SUNDRY NOTICES AND REPORTS ON WELLS

8. Well Name and No. RUTHLESS 11 FED COM/723H

EOG respectfully requests an amendment to our approved APD for this well to reflect the following changes:

Revised Permit Information 03/04/2022:

WELL LOCATION AND ACREAGE DEDICATION PLAT

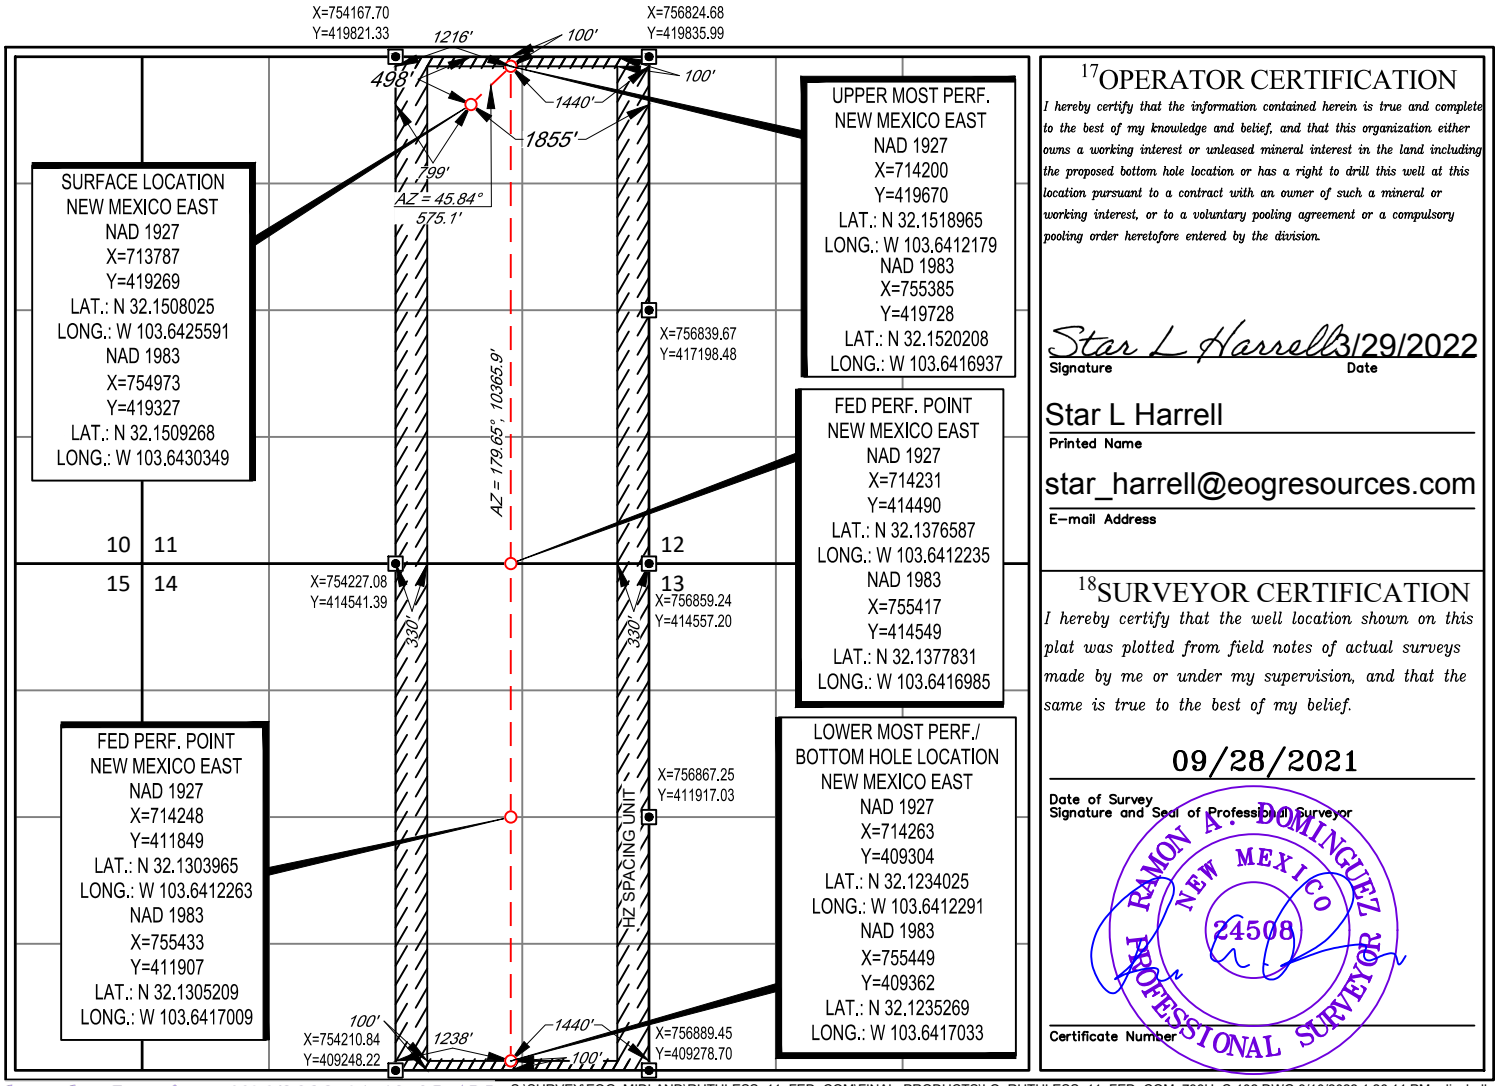
Change BHL from T-25-S, R-32-E, Sec 14, 100' FSL, 1980' FEL, Lea Co., NM, to T-25-S, R-32-E, Sec 14, 100' FSL, 1440' FEL, Lea Co., N.M.

UL or lot no.	Section	Township	Range	Lot Idn	Feet from the	North/South line	Feet from the	East/West line	County
O	14	25-S	32-E	-	100'	SOUTH	1440'	EAST	LEA

Revised Wellbore

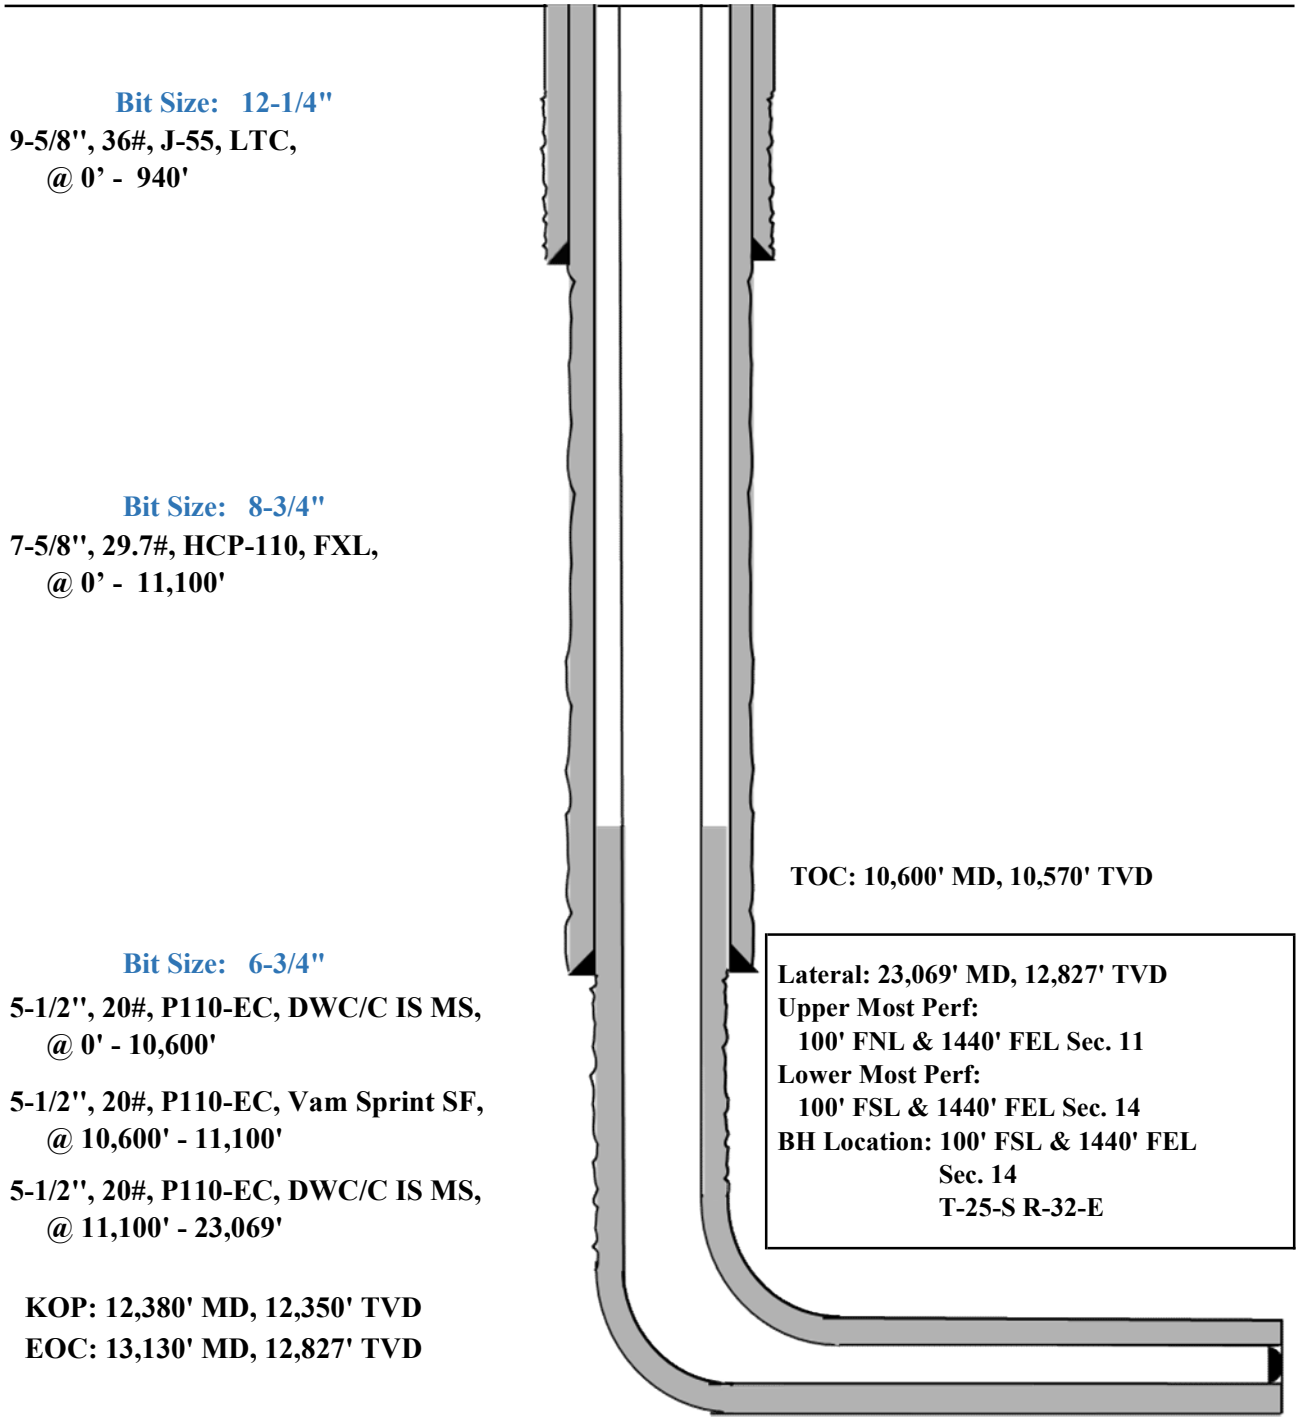
Update casing and cement program to current design.

Hole Size	Interval MD From (ft)	Interval MD To (ft)	Interval TVD From (ft)	Interval TVD To (ft)	Csg OD	Weight	Grade	Conn
12-1/4"	0	940	0	940	9-5/8"	36#	J-55	LTC
8-3/4"	0	11,100	0	11,070	7-5/8"	29.7#	HCP-110	FXL
6-3/4"	0	10,600	0	10,570	5-1/2"	20#	P110-EC	DWC/C IS MS
6-3/4"	10,600	11,100	10,570	11,070	5-1/2"	20#	P110-EC	Vam Sprint SF
6-3/4"	11,100	23,069	11,070	12,827	5-1/2"	20#	P110-EC	DWC/C IS MS

Proposed Wellbore

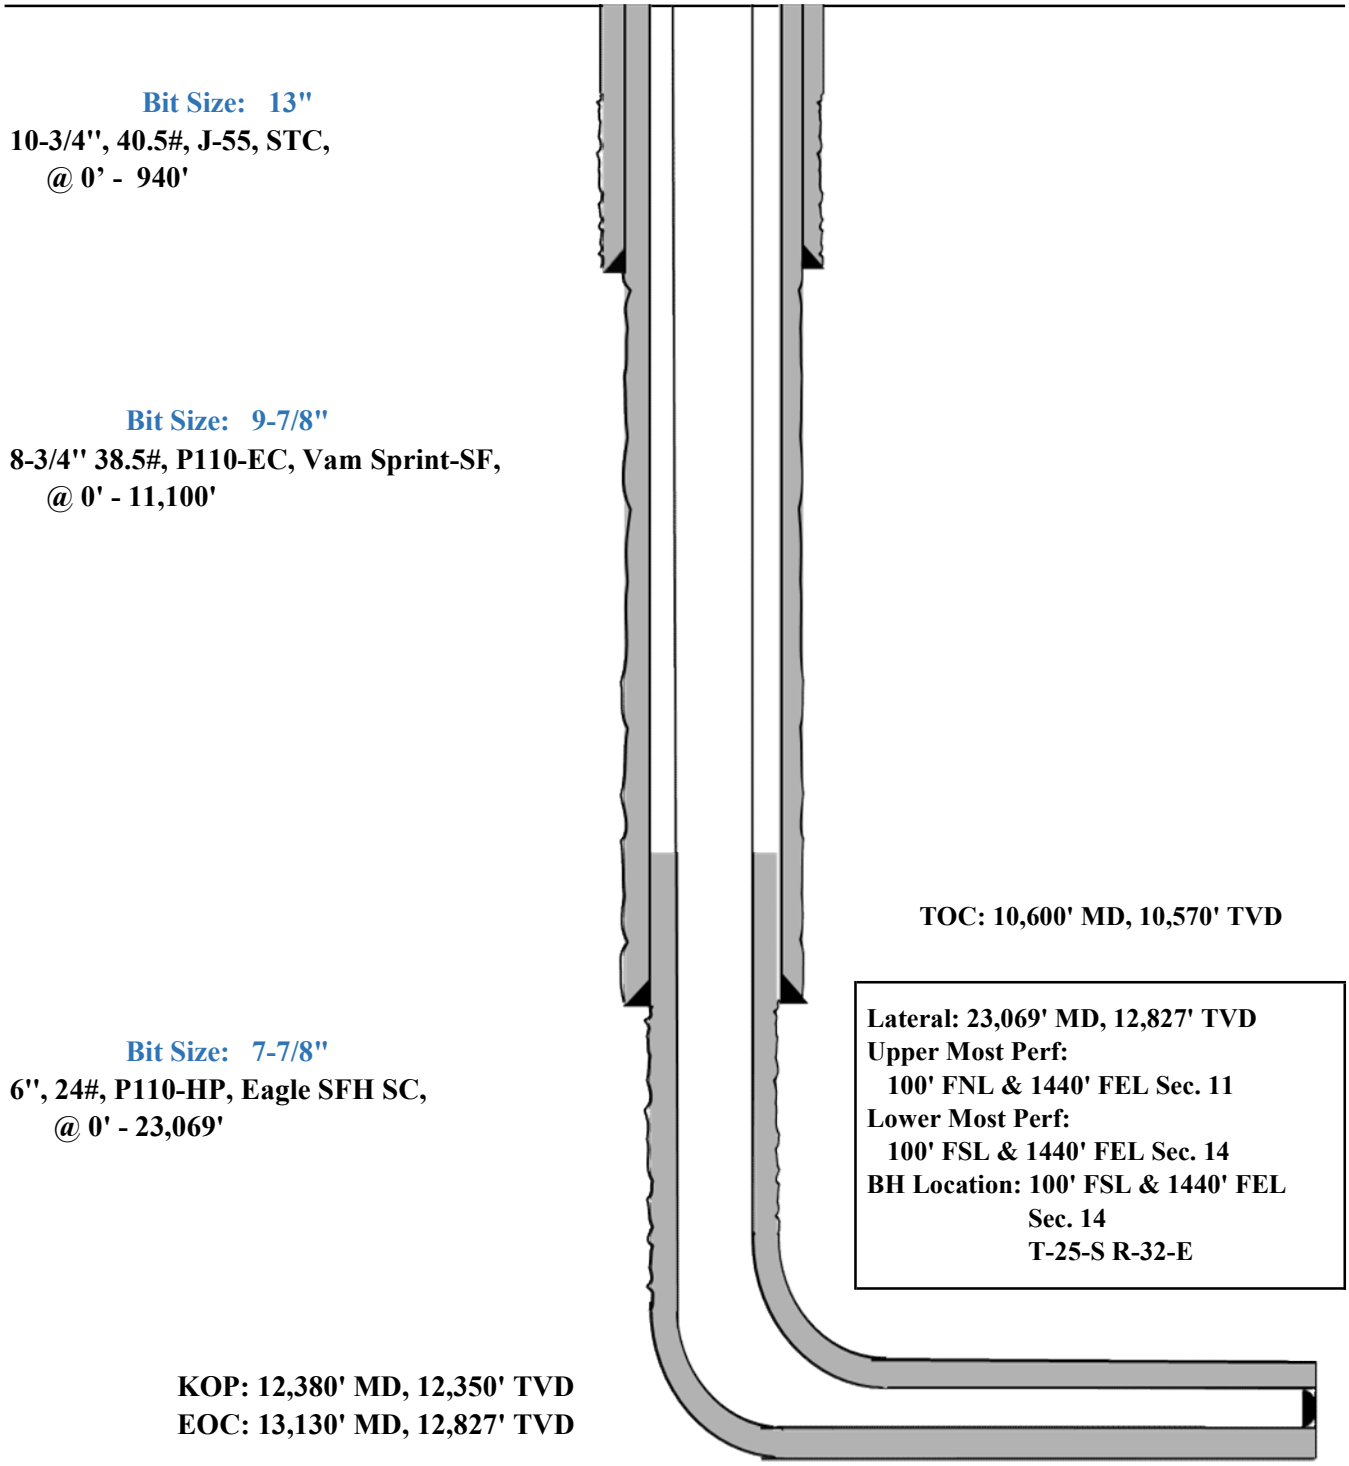
Design B

Hole Size	Interval MD From (ft)	Interval MD To (ft)	Interval TVD From (ft)	Interval TVD To (ft)	Csg OD	Weight	Grade	Conn
13"	0	940	0	940	10-3/4"	40.5#	J-55	STC
9-7/8"	0	11,100	0	11,070	8-3/4"	38.5#	P110-EC	Vam Sprint-SF
7-7/8"	0	23,069	0	12,827	6"	24#	P110-HP	Eagle SFH SC

Figure 1: Cameron TA Plug and Offline Adapter Schematic

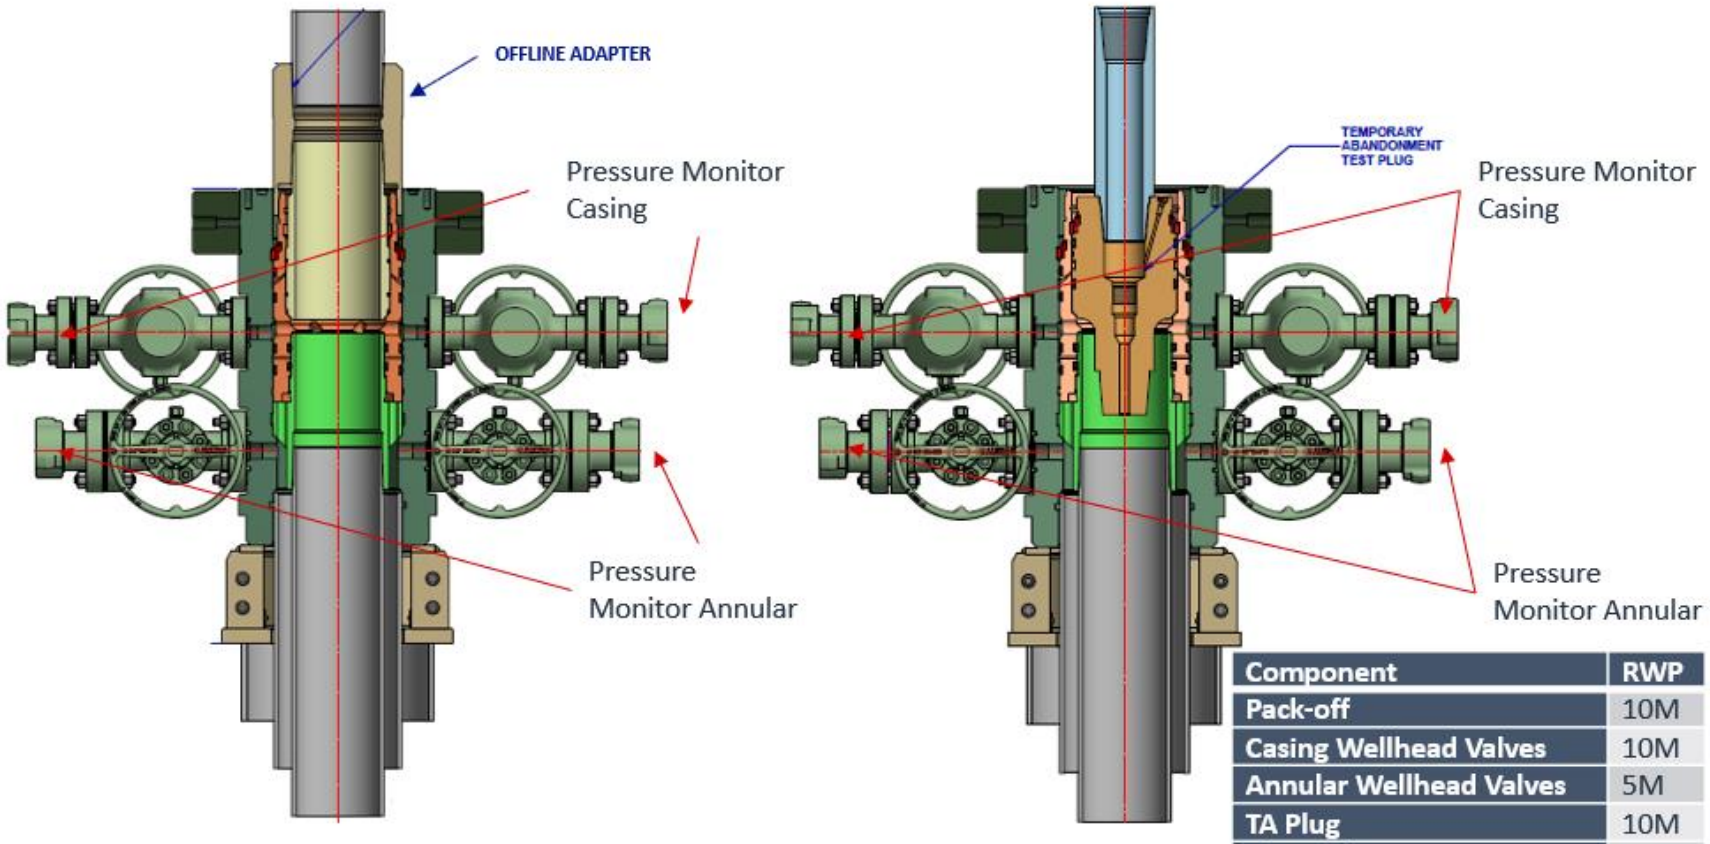
11. Install offline cement tool.
    a. Current offline cement tool schematics can be seen in Figure 1 (Cameron) and Figure 2 (Cactus).
12. Rig up cement head and cementing lines.

Figure 3: Back Yard Rig Up

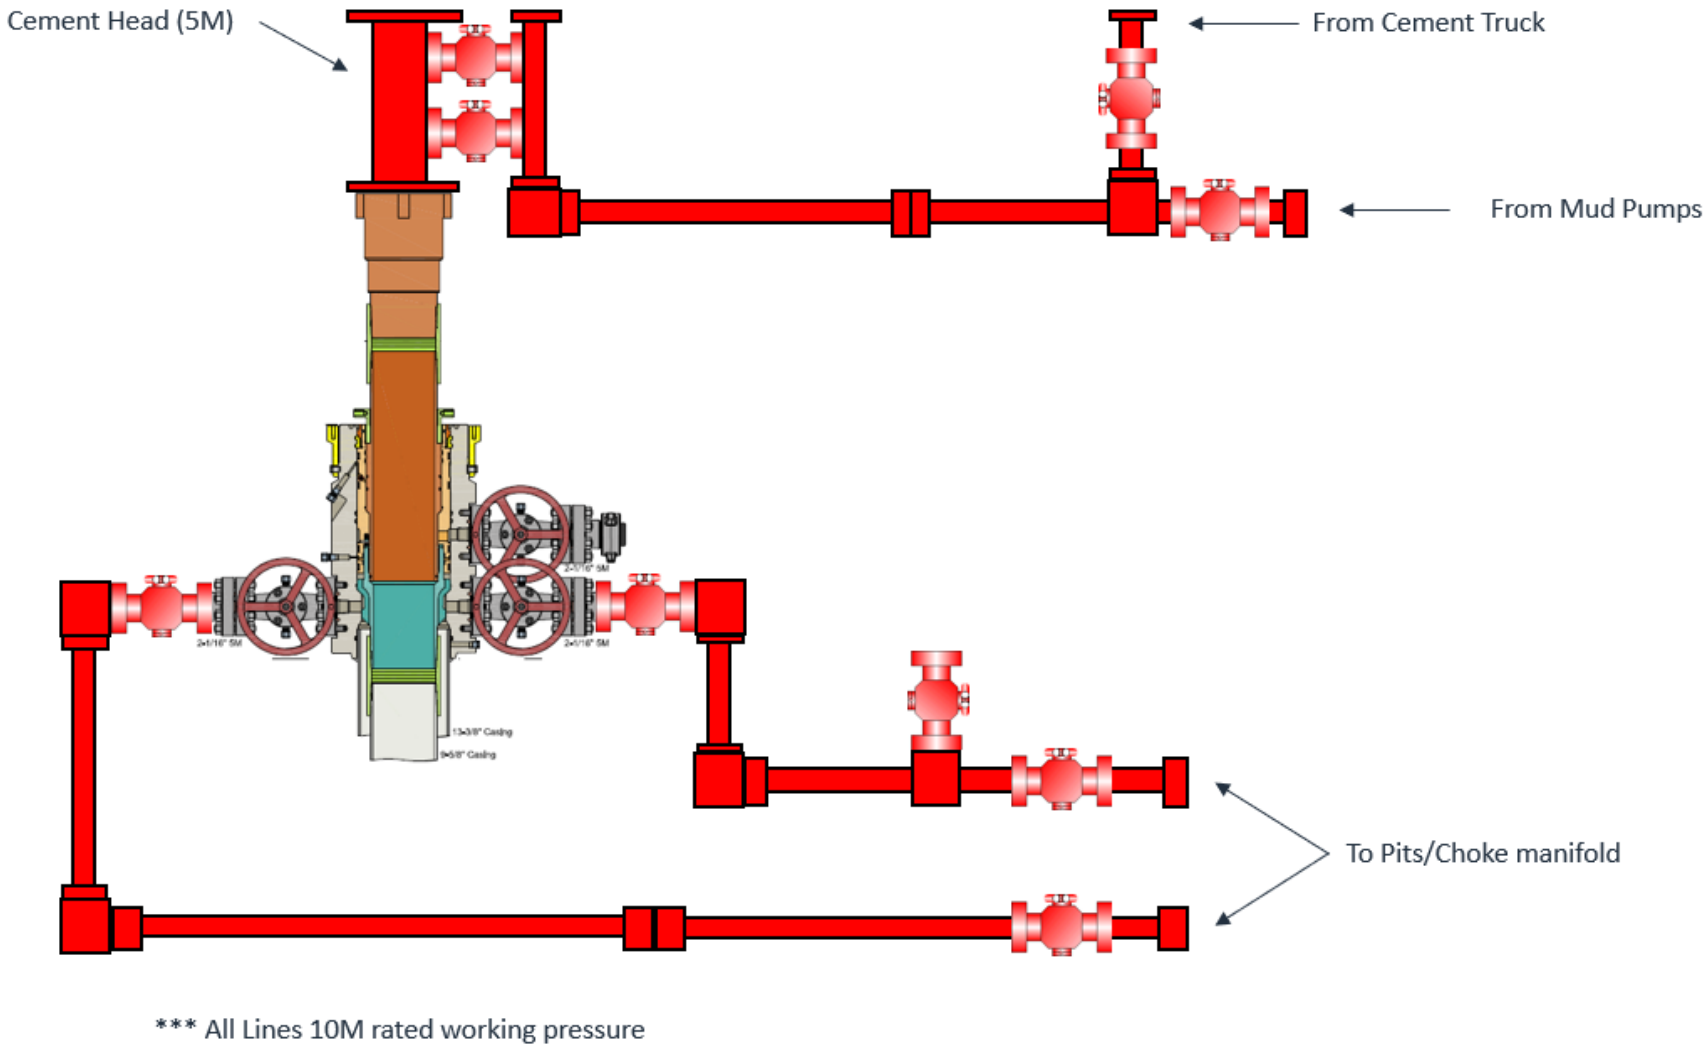
b. If either test fails, perform corrections and retest before proceeding.
    c. Return line schematics can be seen in Figure 3.
10. Remove TA Plug from the casing.

Figure 4: Rig Placement Diagram

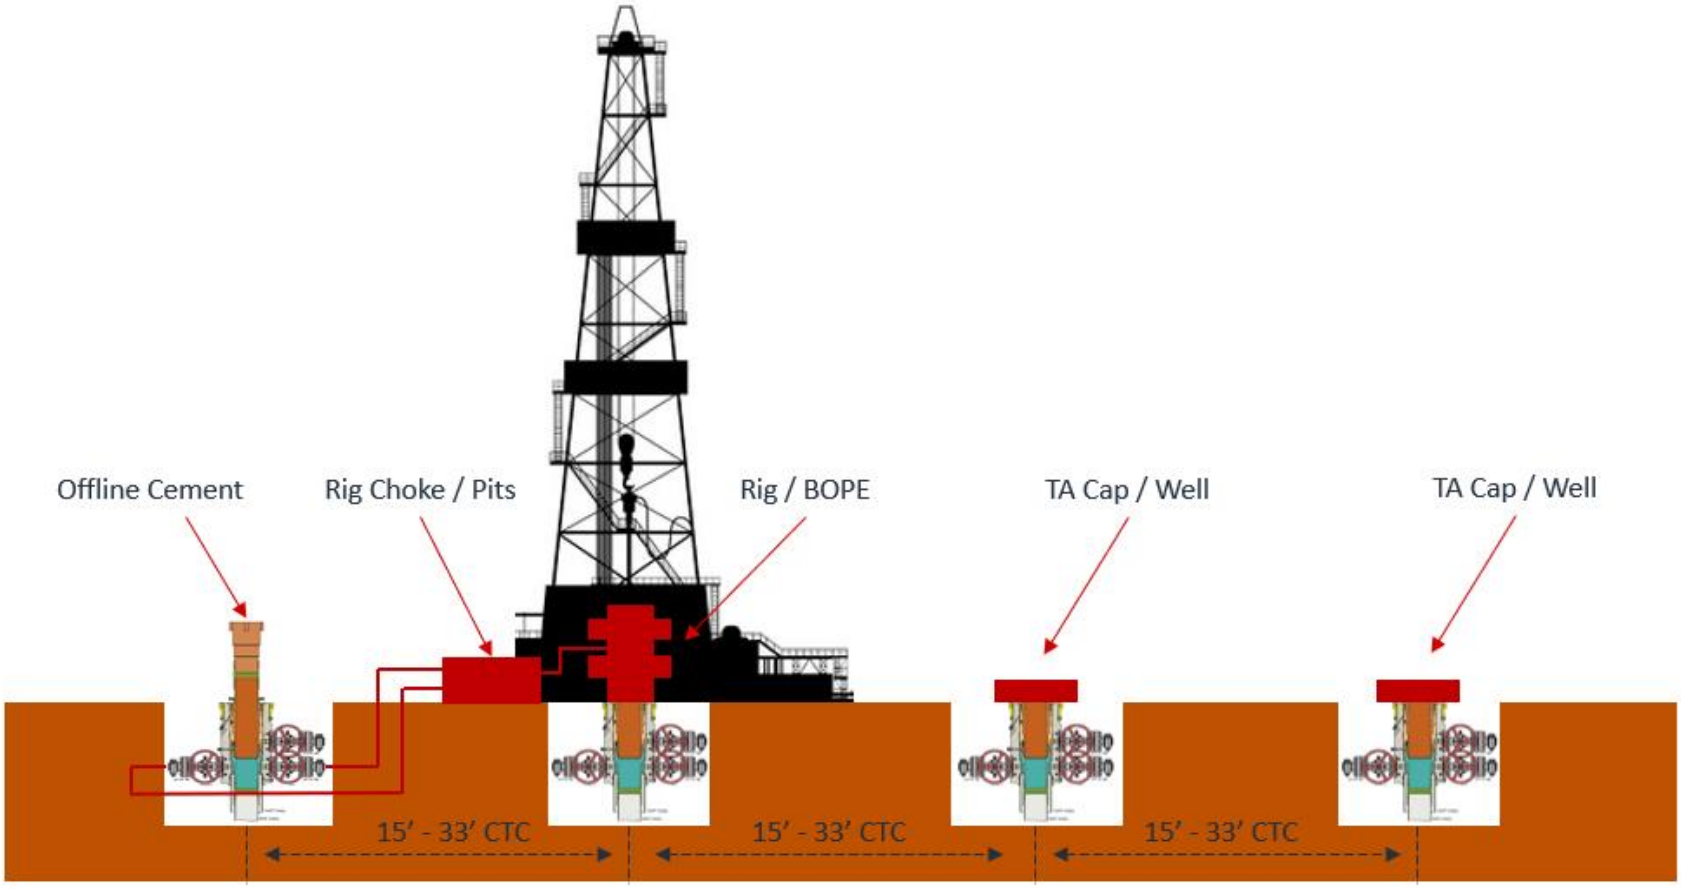
e. Diagram for rig positioning relative to offline cementing can be seen in Figure 4.
